**City of Poughkeepsie
Historic District and Landmarks Preservation Commission
Meeting Agenda**

**RE: Pelton Mount Carmel
36 North Clover Street
Revised Submission**

Re: Project: Pelton Mount Carmel
36 North Clover Street
Re: Revised design of proposed development for HDLPC Approval

WINDOW LEGEND:
REPLACEMENT WOOD WINDOWS U.O.N.
EXISTING WINDOWS TO BE RESTORED

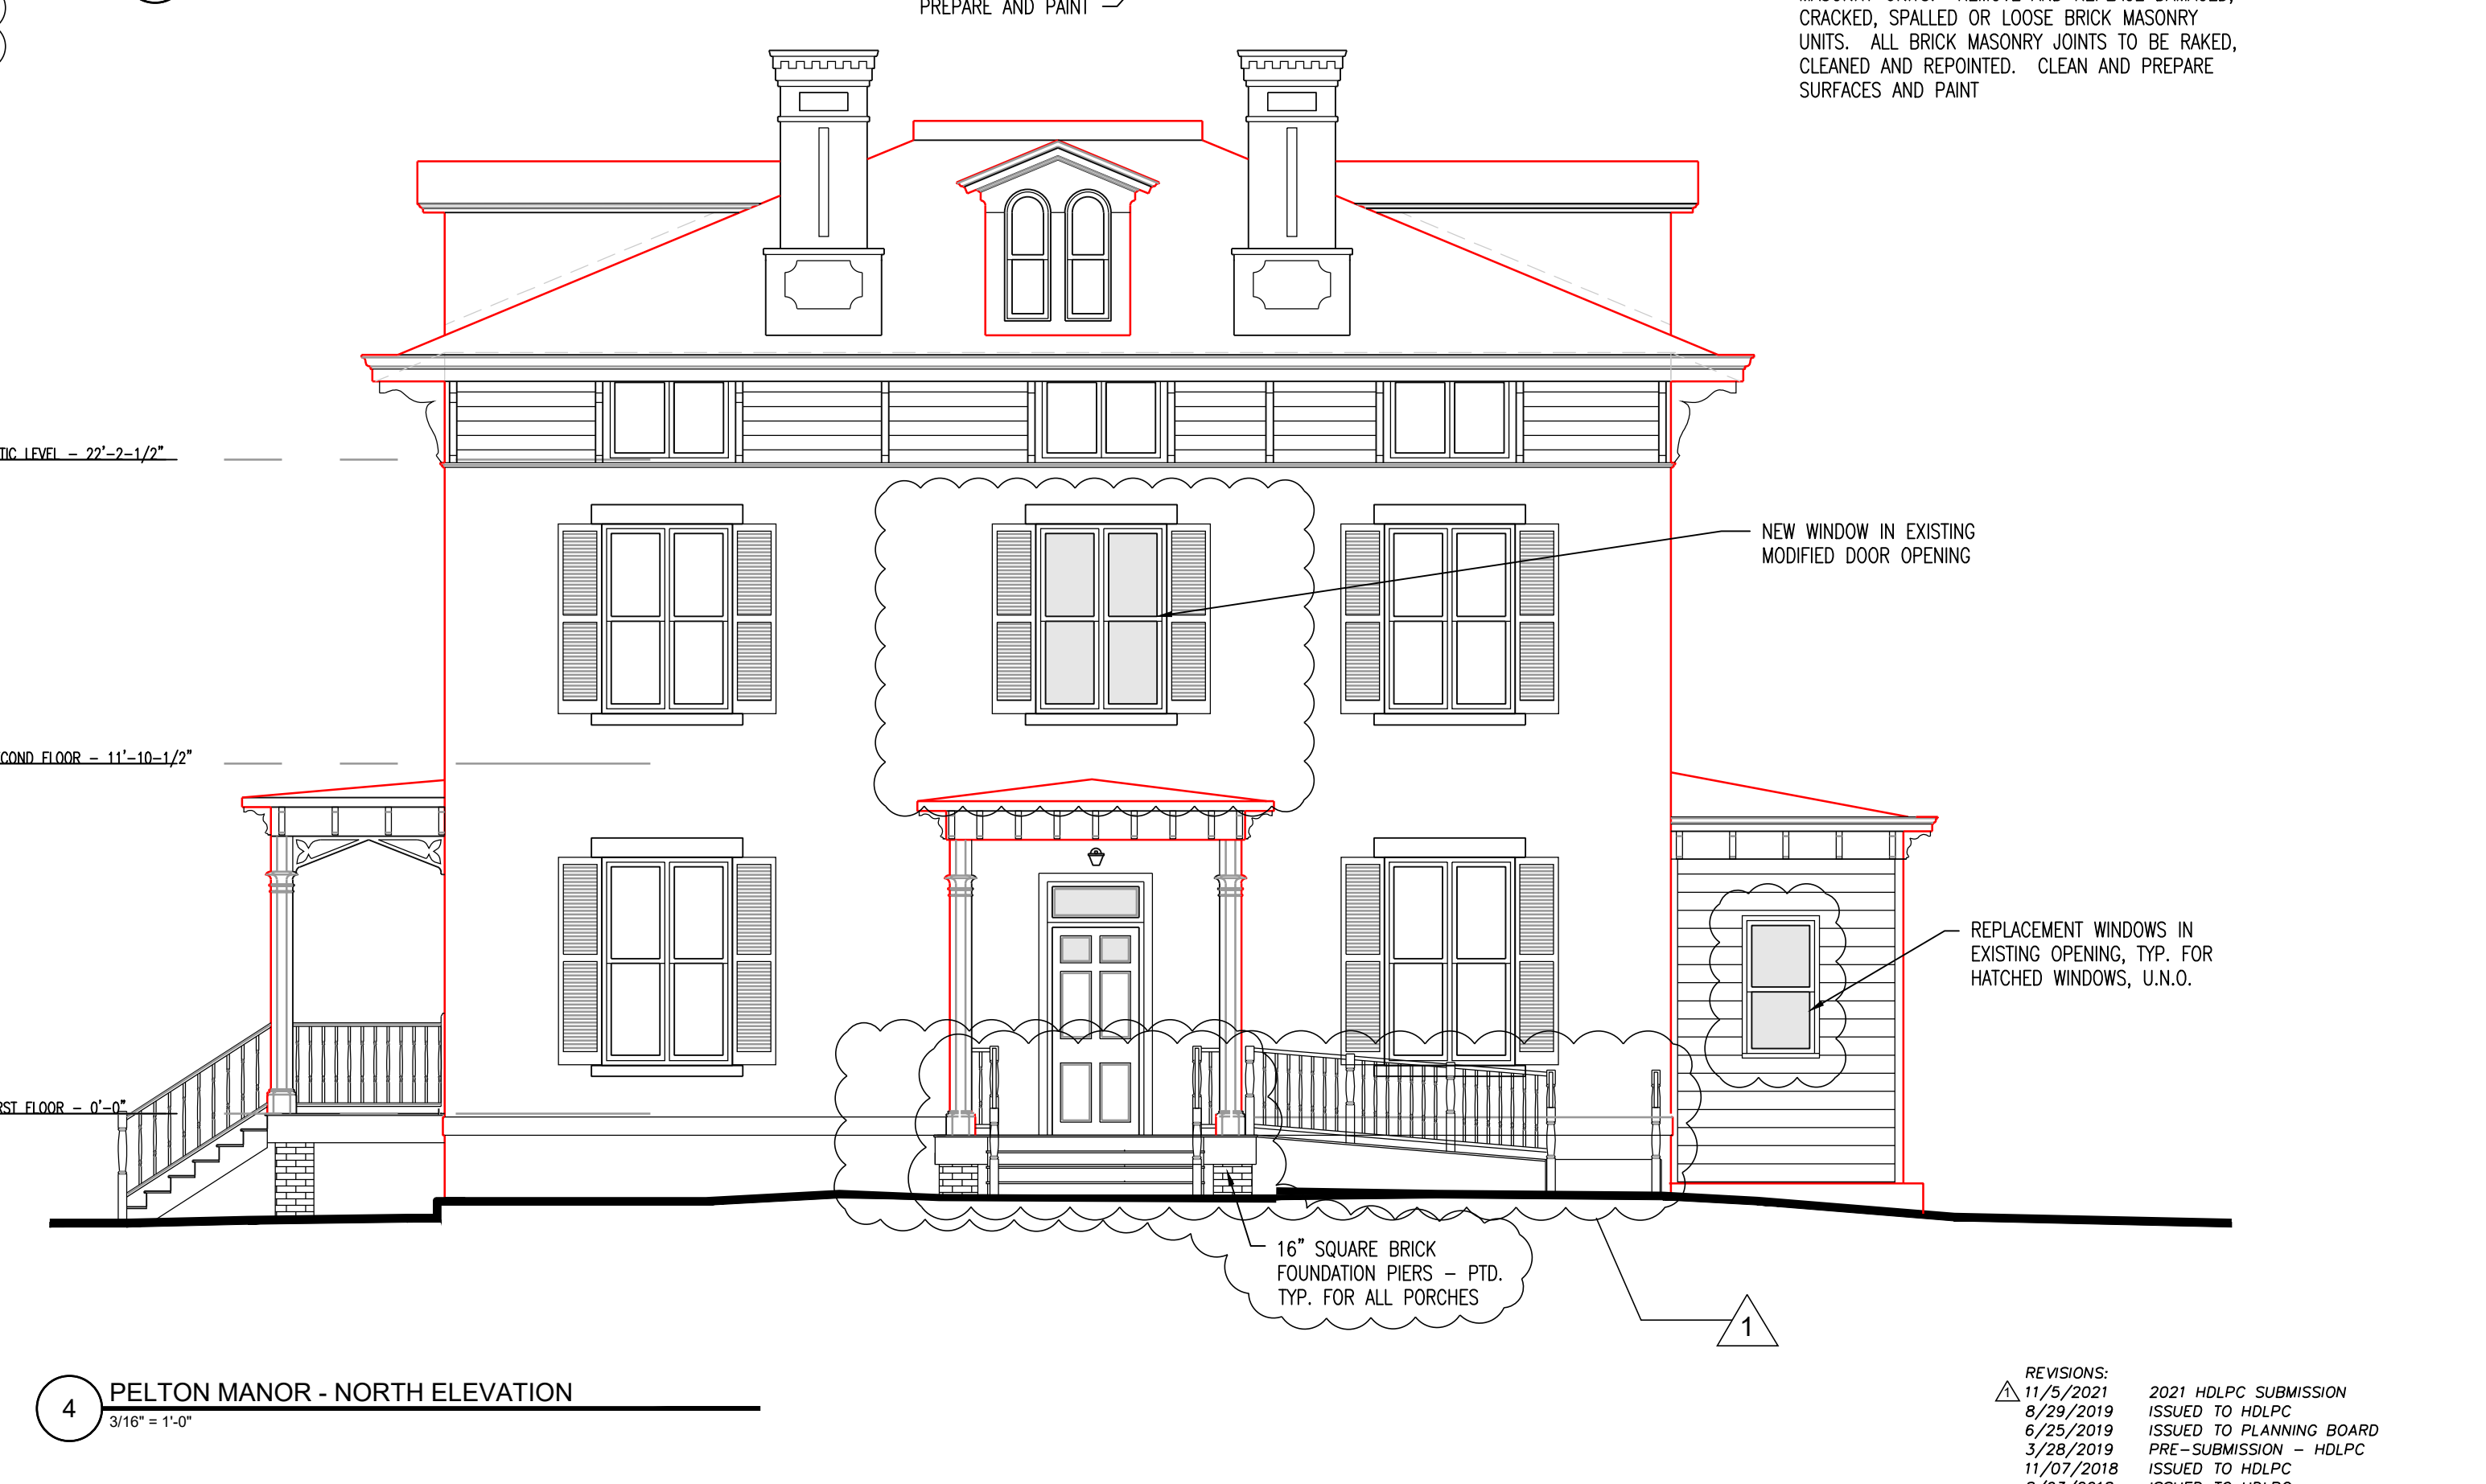
Sheet PZ-08 – Preliminary Elevations – Pelton Manor:

1. Elevations 1, 2 & 4 have been modified to include the elevations of the proposed handicap ramp being proposed for the north side of the Pelton Manor.

PRELIMINARY ELEVATIONS - FALLKILL		
DRAWN BY:	J.D.	PZ-10
JOB No.	Y1022	
DATE:	7/5/17

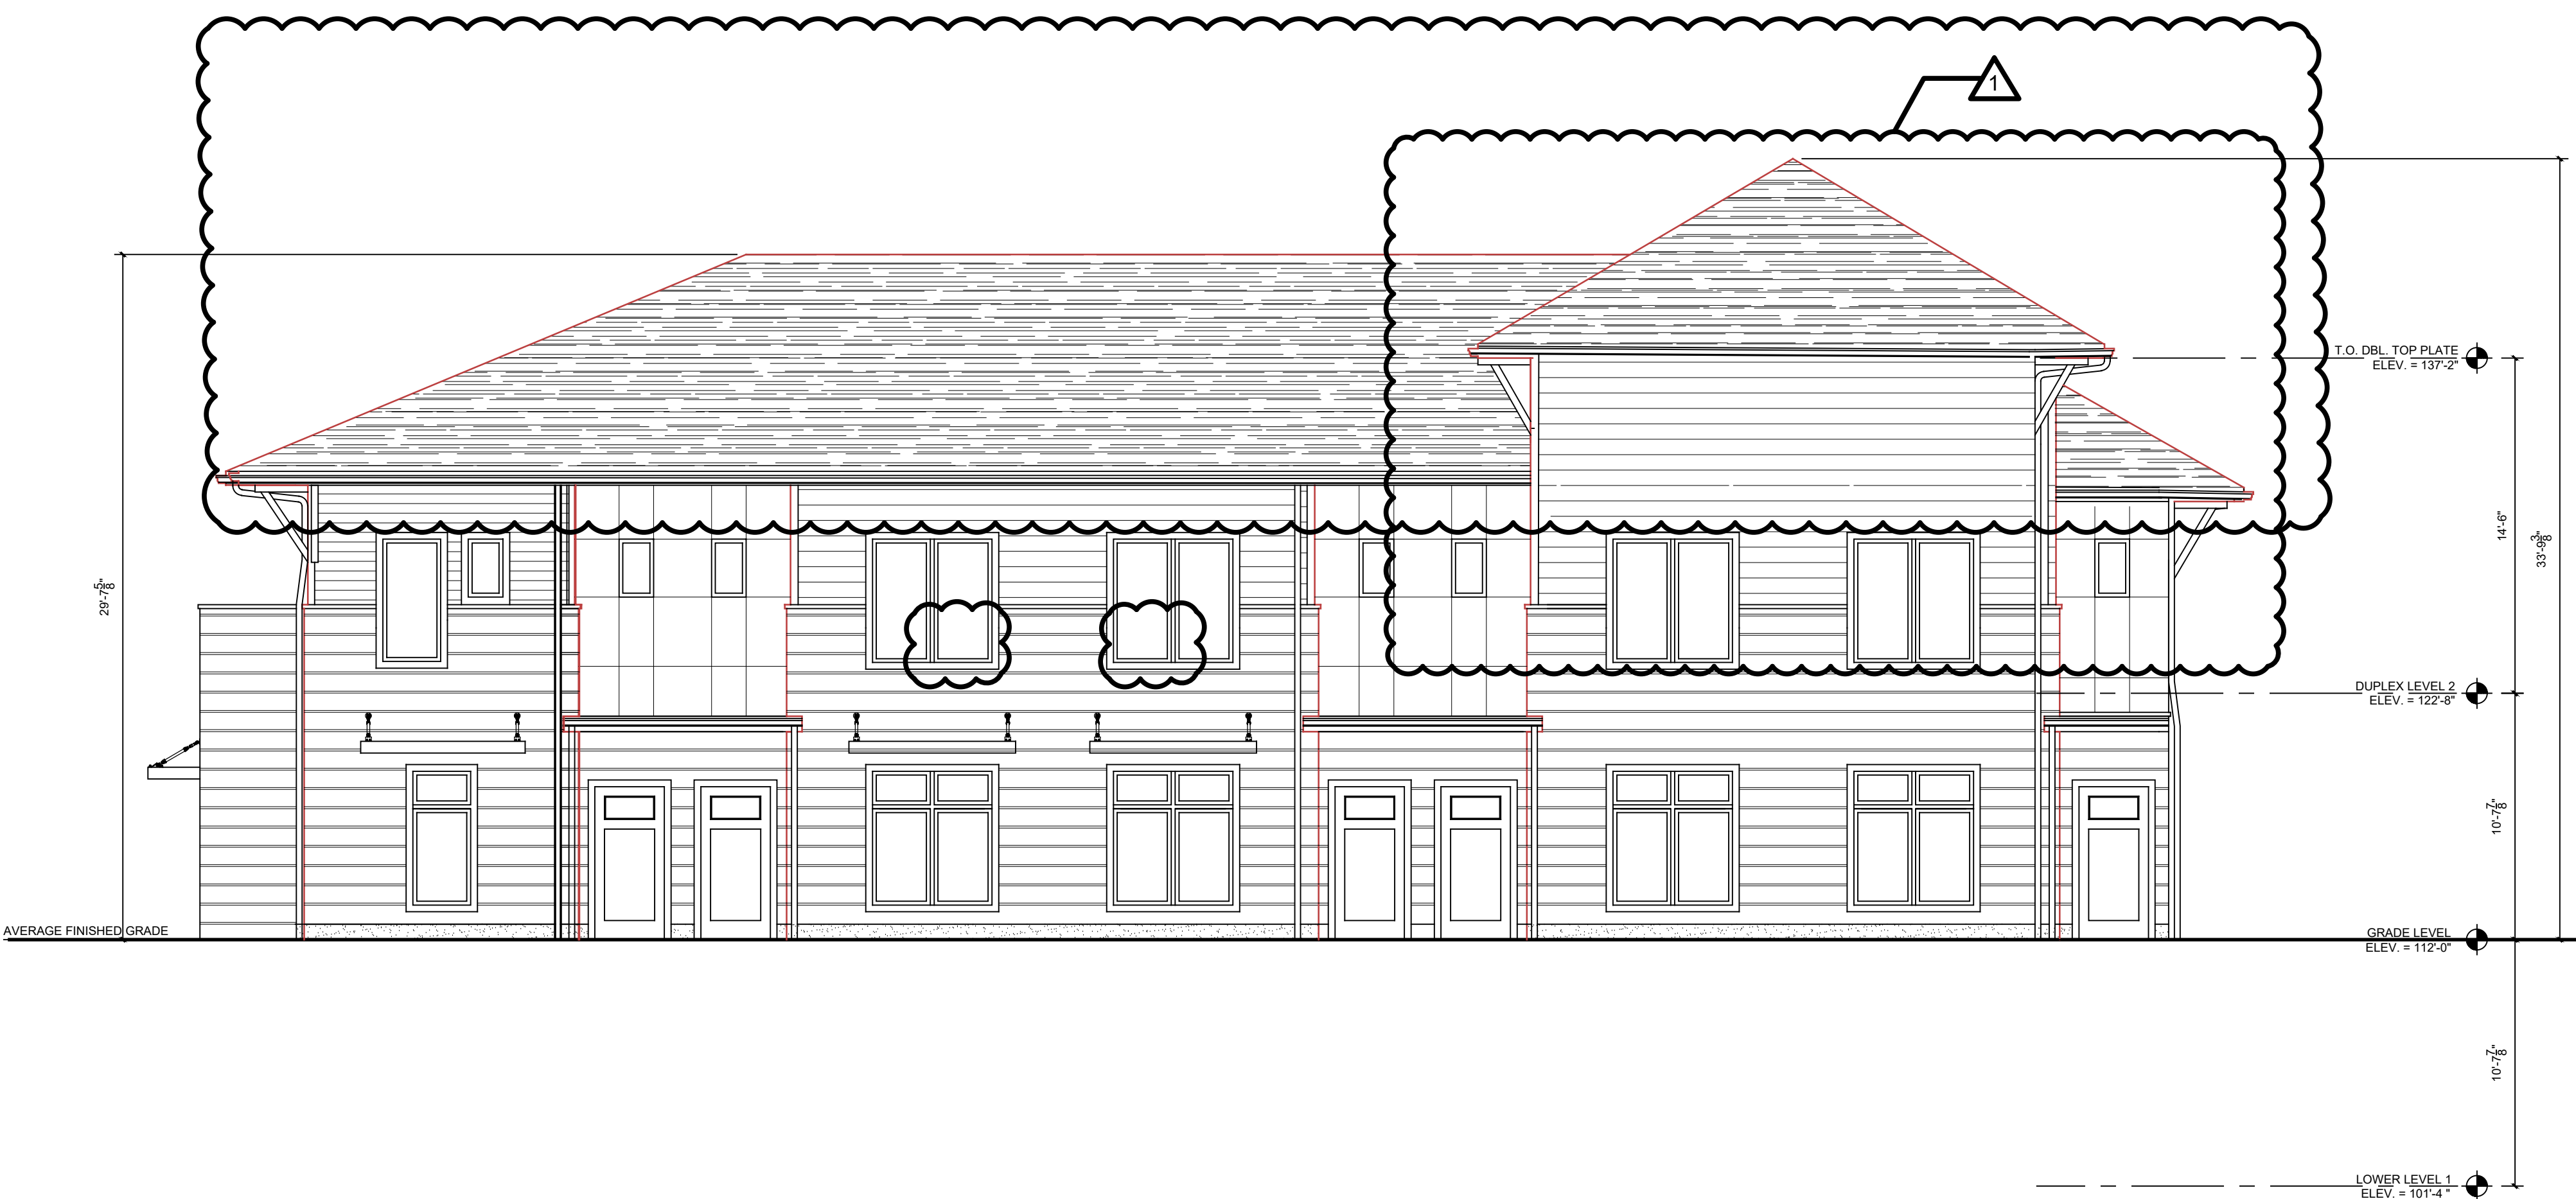
Sheet PZ-10 – Preliminary Elevations – Fall Kill:

1. On all elevations, the Upper Duplex Level 2 has been removed thus lowering the height of the building.
2. The ridgeline of the roof has been lowered to a height of 33'-9 3/8"
3. A "Tower" element has been created on the north and the south elevations of the building, reducing the width of this form. Refer to Elevations 1 & 4.
4. Elevation 3 – Fall Kill West Elevations
 - a. The Lower Duplex Level 1 has been modified to accommodate the proposed commercial space. This includes changes the elimination of a window for the former residential unit.
5. Elevation 4 – Fall Kill North Elevation
 - a. The Lower Duplex Level 1 has been modified to accommodate the proposed commercial space. This includes changes in the building materials and the window configuration in this area and the elimination of a door to the former residential unit.
